Report prepared by Alastair Hamilton, Lead Officer

EXTENSION TO BALMULLO QUARRY AND CONSTRUCT
NEW ACCESS ROUTE TAT BALMULLO QUARRY LUCKLAW
QUARRY ROAD BALMULLO FIFE

Planning App. 05/00835/EEIA

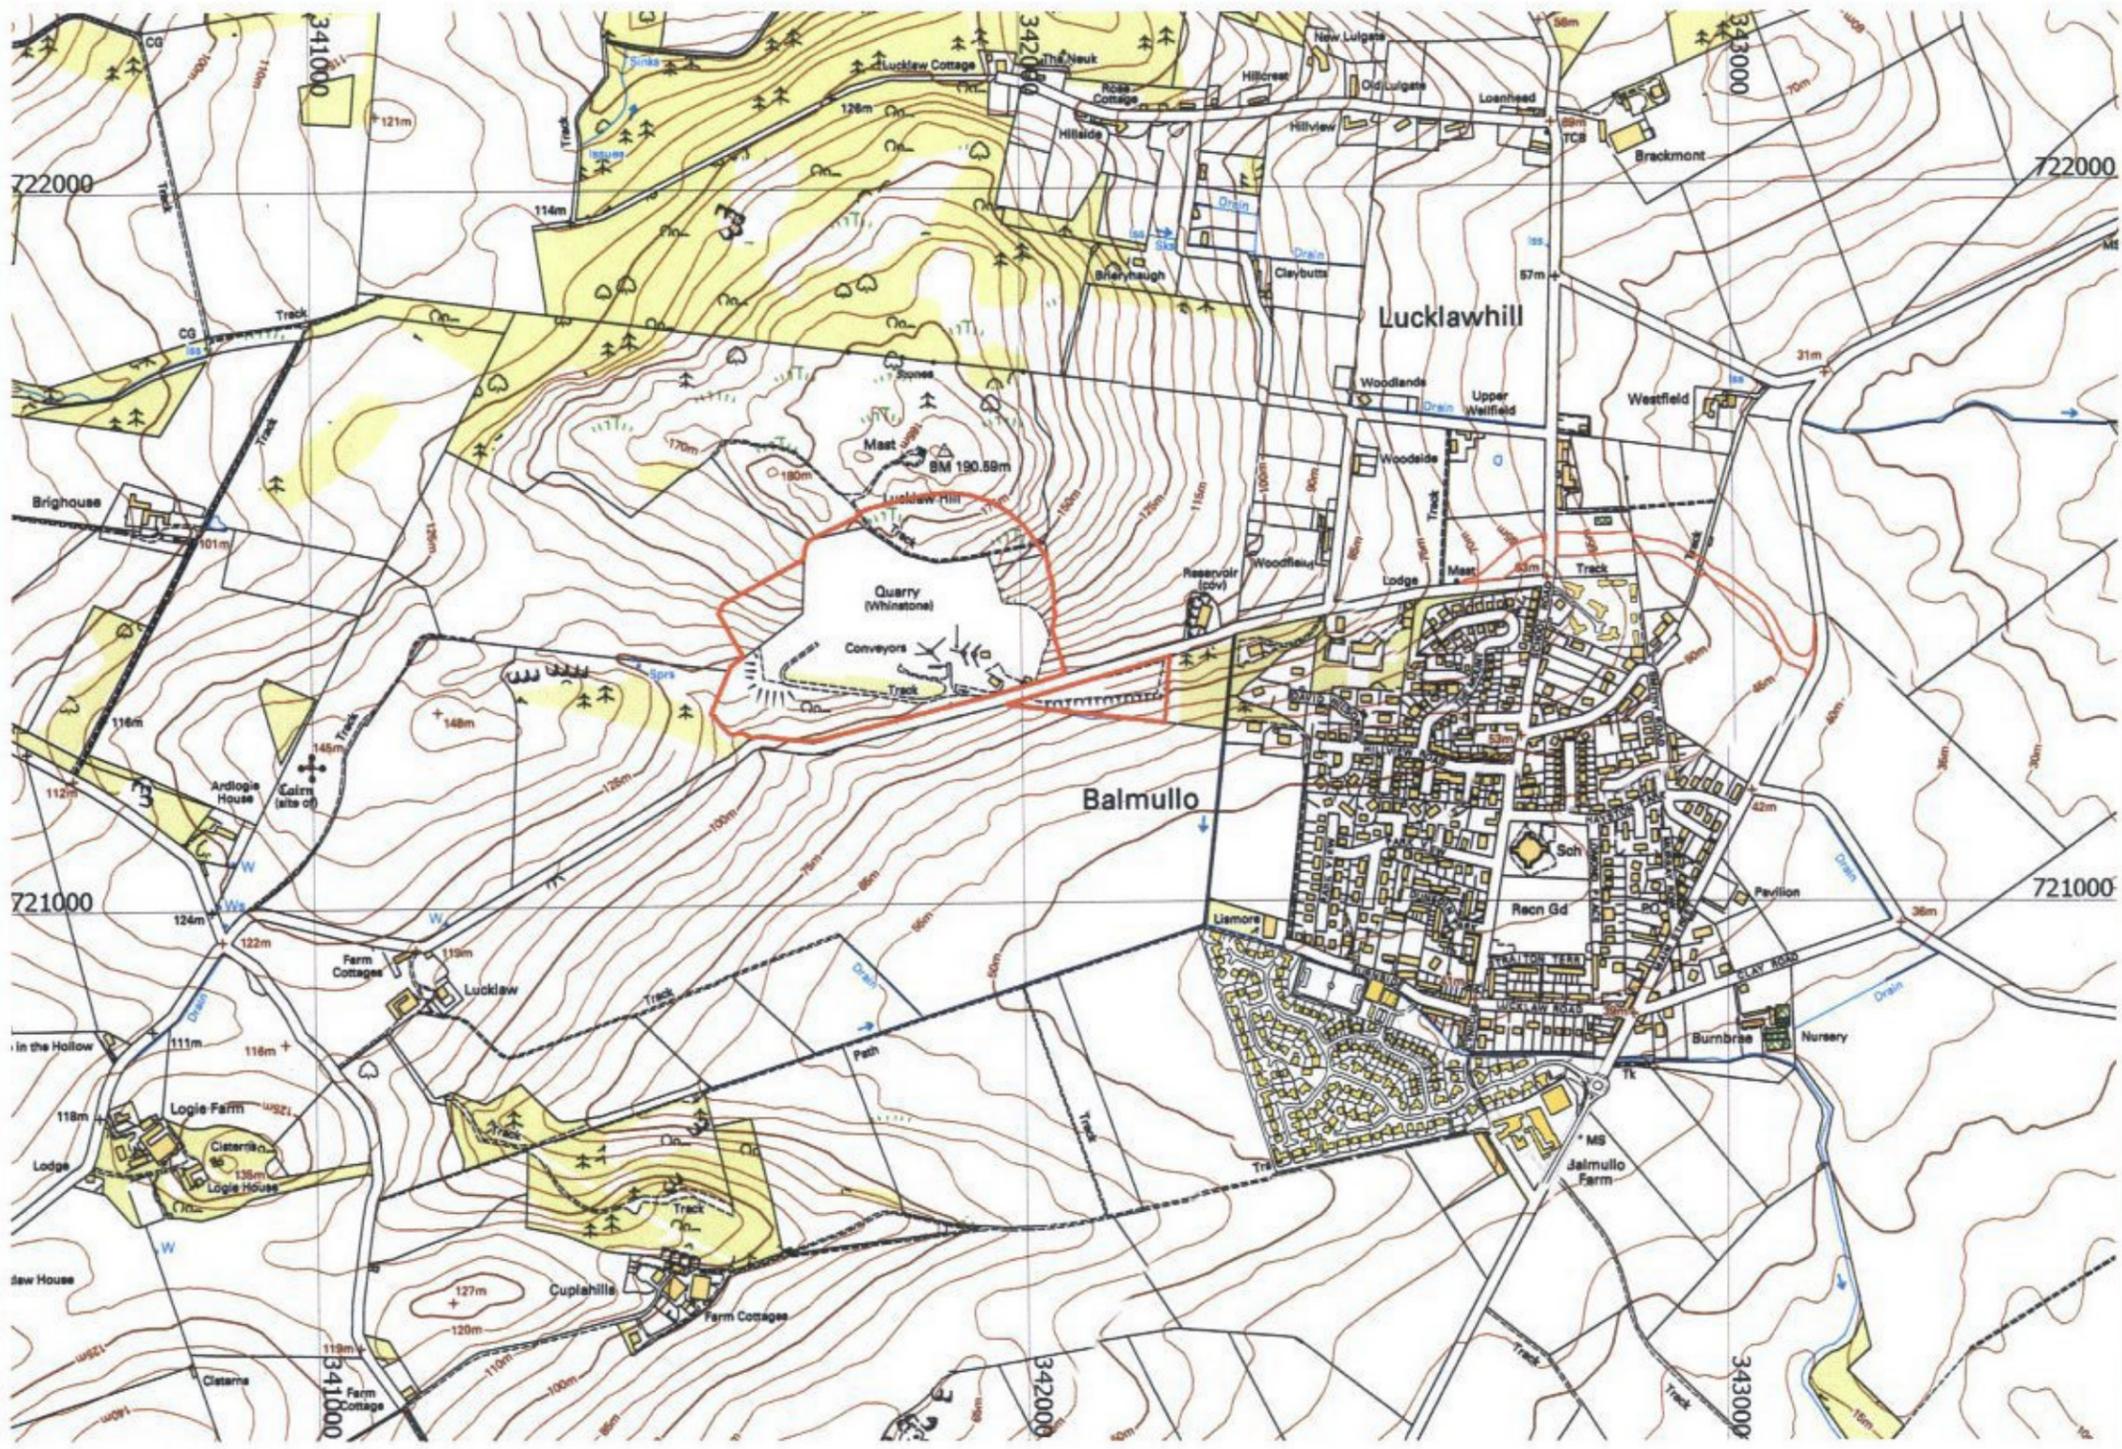
This is the footpath which would be destroyed
